BAR Meeting
February 6, 2013

ISSUE: After-the-Fact Certificate of Appropriateness &
Waiver of Section 7-202(C) (Fence Height Requirement)

LOCATION: 516 North Columbus Street

BAR2012-00364

Deck

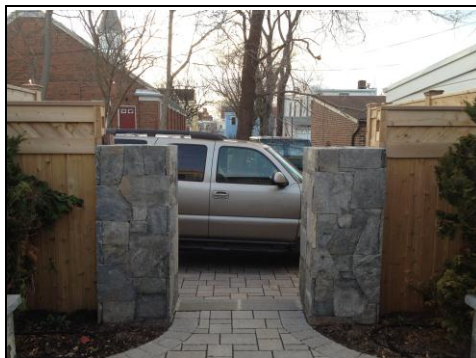
The BAR's *Design Guidelines* state that "Fences, in the historic districts are made of a number of materials including wood, masonry and brick." "New fences should be sympathetic to the existing built environment and appropriate in materials, design and scale." Staff finds that the installed wood fences comply with the requirements of the *Design Guidelines*. The fence design is consistent with other existing fences within this portion of the district and has no negative impact on historic features, as it is completely detached from the historic structure and contained in the rear yard, visible only from the public alley and, of course, the adjoining neighbor's yards. If the Board approves the new rear fence and the taller side fences, the reconstructed rear deck will be minimally visible and staff recommends approval of the new design, which is far more attractive and architecturally appropriate than the previous utilitarian deck. Staff notes again that the open space issues must be resolved and this recommendation relates only to the architectural character of the visible portions of the railing, which may have to be relocated to the original deck rail location.

C-2 On June 15, 2012, a permit to replace the deck rails and steps was issued. The applicant appears to have enlarged the deck and stairs, further reducing the open space. The applicant must reduce the deck and stairs so that no open space is lost.

Piers and Future Gate Location

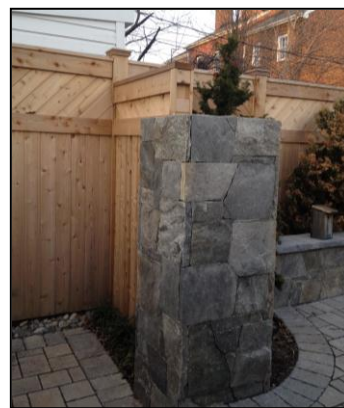
The present case before the BAR is for after-the-fact approval of new fence and stone piers on the west side of the property, a waiver of fence height and design approval for fences *exceeding 6' in height, with the maximum height of 7'-10"* on the north and south lot lines, approval of a

Staff notes that the Board has, on occasion, approved fences which are seven feet above the adjacent grade, including the most recent fences at 909 and 911 South Saint Asaph Street (BAR 2012-0259 & 260) 9/5/12). Staff recommends that the Board find that the proposed wood fence with masonry piers architecturally appropriate and consistent with the character of the district and supports the waiver of Section 7-202(C) ***to the waiver of the height requirement to a maximum of 7'-10", in conformance with the submitted plat.***

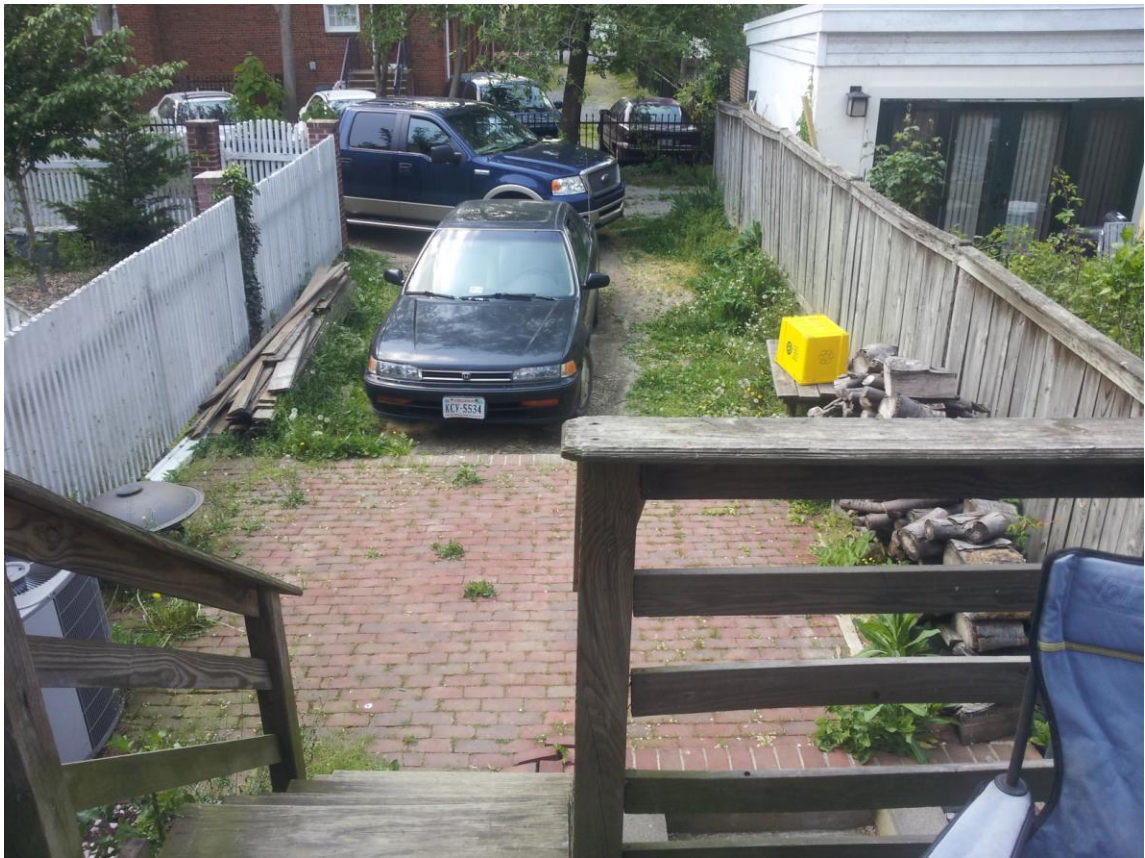
C-1 In 1990, a two-story addition was approved on the property. At that time the applicant proposed parking at the rear of the property. In order to comply with the required 800 square feet of open space staff determined that rear of the property could **not** be used for parking. According to the submitted survey, the property provided approximately 707

square feet of open space (staff must determine if any of the area in the front of the building can be included in the open space). The open space cannot be reduced below the amount that exists on the submitted plat, dated August 14, 2002. The rear of the property may **not** be used for parking. A barrier between the alley and the rear of the lot must be erected.
